## 1.0 APPLICATION SUMMARY

Request: Minor Modification to PD 19-0745

**Proposed PRS 25-0156** requests to amend the existing Conditions of Approval and site plans. Revisions include reducing the parking requirement for warehouse use, changing the western cross access from required to option of developer, and removing the truck restriction on Patterson Road.

APPLICATION NUMBER: PRS 26-0156

Proposed Typical Section- Approved by Design Exception

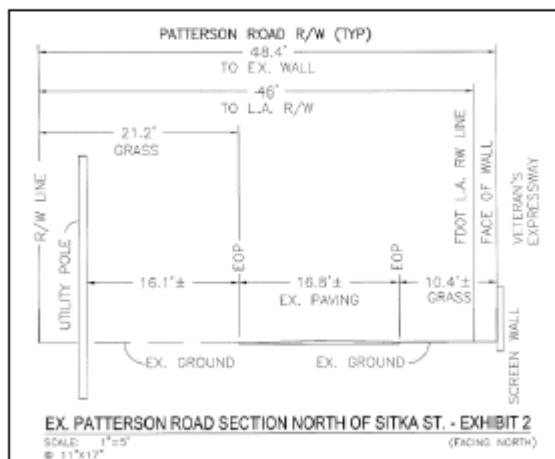
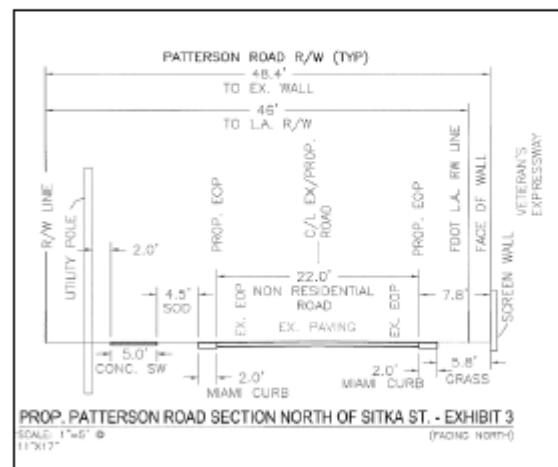
- Design Exception – The request is for de minimis change to provide construction limits to the Design Exception approved by the County Engineer (dated July 24, 2019). The request is to affirmatively state the termini of the Patterson Road construction project as being from the Patterson Road/Sitka Road intersection to the northernmost project driveway.

- The developer shall be permitted to utilize 11-foot wide travel lanes (for both through lanes and turn lanes) in lieu of the 12-foot wide travel lanes typically required by the Hillsborough County Transportation Technical Manual's (TTM) TS- 3 Typical Section; and,
- 5' sidewalk on the western side with 2' clearance to on both sides of the road
- 4.5' of sod from the sidewalk to the back of Miami Curb
- 2' curb and gutter on the west side of Patterson
- 2' Miami curb on the east side of Patterson Rd
- 5.8' grass (adjacent to FDOT 8'cmu wall)

**PROP. PATTERSON ROAD SECTION NORTH OF SITKA ST. - EXHIBIT 3**

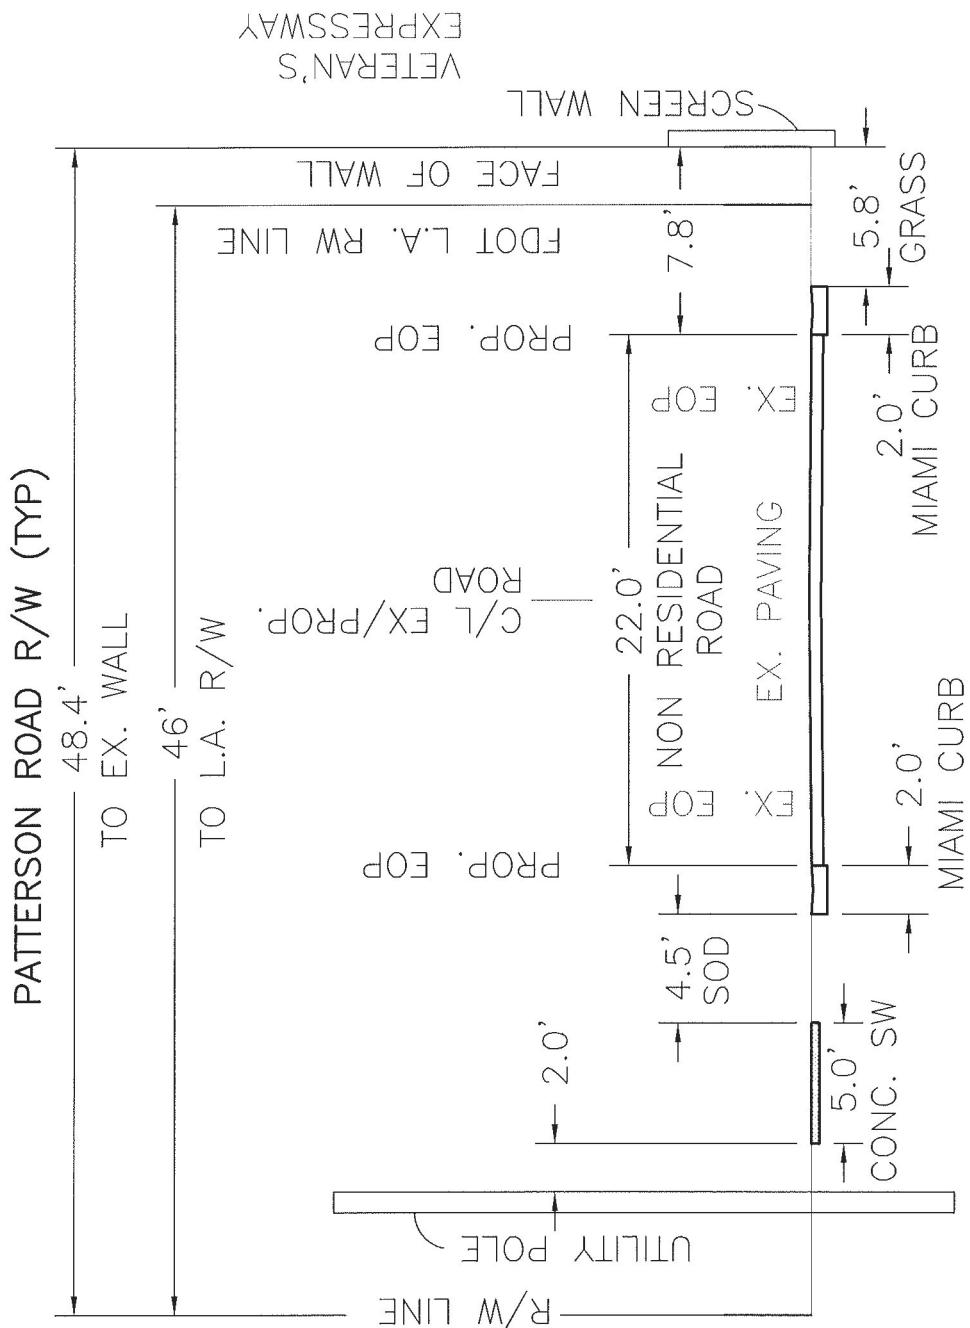
- Shift the proposed sidewalk to provide 2 ft. flat area between the back of sidewalk and RoW line, 1 ft. is possible if it helps with existing power pole conflicts.  
*Response: The poles only impact the sidewalk by approximately 0.8', leaving 4.2' of clearance which meets ADA standards. It is my professional opinion that the sidewalk will work along the RW line. See TS-3 note 3, 2 ft. flat is specified, can go to 1 ft. flat (both sides of sidewalk) if added as a DE element.*

- Exhibit 3, label curb type, assume miami.  
*Response: The curb has been labeled as Miami Curb. Confirmed*
- Recommend shifting the roadway alignment west to provide 6 ft. min from the EoP (not back of curb) to the cmu wall, considering its 10.4 ft. today and the added traffic.  
*Response: Given the reduced lane widths indicated below, we can maintain the existing road center line and provide over 7' from the eop to the face of the wall. Maintaining the center line will make for a better transition from the new to the existing road way as Patterson Road continues north and ties into W. Sitka Street south of the project. Good idea*

- May want to consider 11 ft. travel lanes, can act to calm traffic/reduce speeds – unless heavy truck traffic is expected, I don't recall.  
*Response: The PD has restrictions on heavy truck traffic & we agree that 11' travel lanes are appropriate for the project and have implemented the change. Confirmed*

- Its noted, due to the Veterans, there are no pedestrian destination on the east side of Patterson Rd within the improvement limits, supporting no east side sidewalk.  
*Response: We agree and appreciate your support for the exception. Confirmed*

Proposed Typical Section- Approved by Design Exception

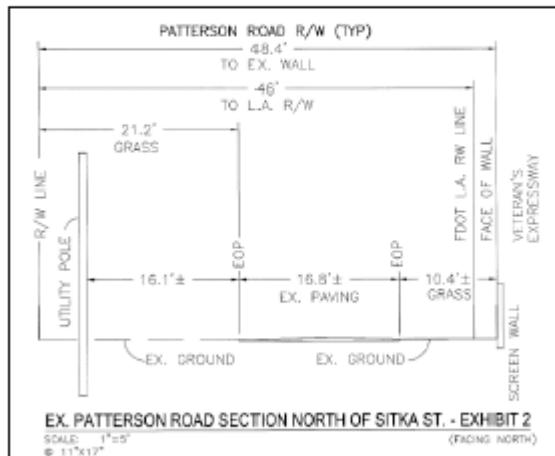
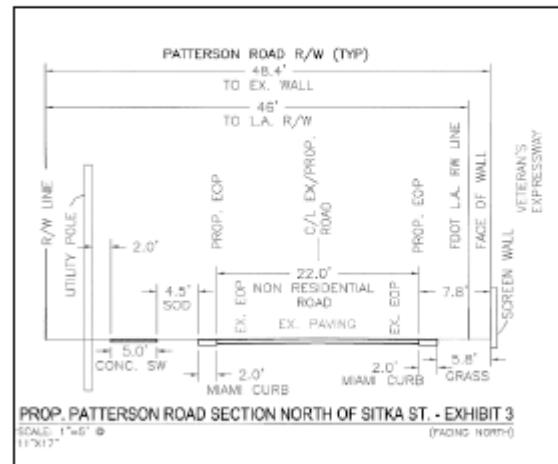
- Design Exception – The request is for de minimis change to provide construction limits to the Design Exception approved by the County Engineer (dated July 24, 2019). The request is to affirmatively state the termini of the Patterson Road construction project as being from the Patterson Road/Sitka Road intersection to the northernmost project driveway.

- The developer shall be permitted to utilize 11-foot wide travel lanes (for both through lanes and turn lanes) in lieu of the 12-foot wide travel lanes typically required by the Hillsborough County Transportation Technical Manual's (TTM) TS- 3 Typical Section; and,
- 5' sidewalk on the western side with 2' clearance to on both sides of the road
- 4.5' of sod from the sidewalk to the back of Miami Curb
- 2' curb and gutter on the west side of Patterson
- 2' Miami curb on the east side of Patterson Rd
- 5.8' grass (adjacent to FDOT 8'cmu wall)

**PROP. PATTERSON ROAD SECTION NORTH OF SITKA ST. - EXHIBIT 3**

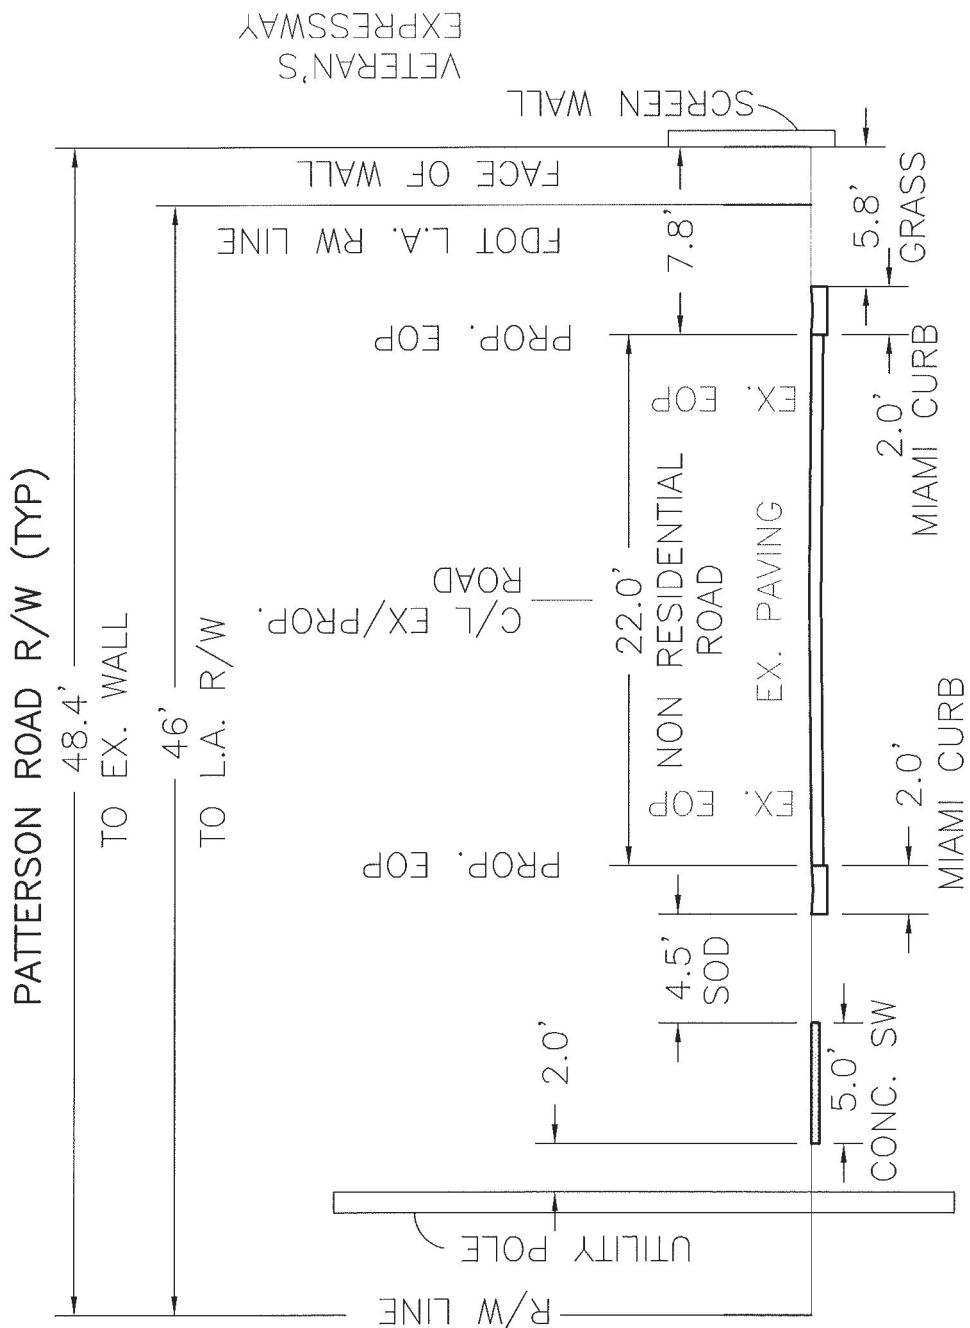
- Shift the proposed sidewalk to provide 2 ft. flat area between the back of sidewalk and RoW line, 1 ft. is possible if it helps with existing power pole conflicts.  
*Response: The poles only impact the sidewalk by approximately 0.8', leaving 4.2' of clearance which meets ADA standards. It is my professional opinion that the sidewalk will work along the RW line. See TS-3 note 3, 2 ft. flat is specified, can go to 1 ft. flat (both sides of sidewalk) if added as a DE element.*

- Exhibit 3, label curb type, assume miami.  
*Response: The curb has been labeled as Miami Curb. Confirmed*
- Recommend shifting the roadway alignment west to provide 6 ft. min from the EoP (not back of curb) to the cmu wall, considering its 10.4 ft. today and the added traffic.  
*Response: Given the reduced lane widths indicated below, we can maintain the existing road center line and provide over 7' from the eop to the face of the wall. Maintaining the center line will make for a better transition from the new to the existing road way as Patterson Road continues north and ties into W. Sitka Street south of the project. Good idea*

- May want to consider 11 ft. travel lanes, can act to calm traffic/reduce speeds – unless heavy truck traffic is expected, I don't recall.  
*Response: The PD has restrictions on heavy truck traffic & we agree that 11' travel lanes are appropriate for the project and have implemented the change. Confirmed*

- Its noted, due to the Veterans, there are no pedestrian destination on the east side of Patterson Rd within the improvement limits, supporting no east side sidewalk.  
*Response: We agree and appreciate your support for the exception. Confirmed*
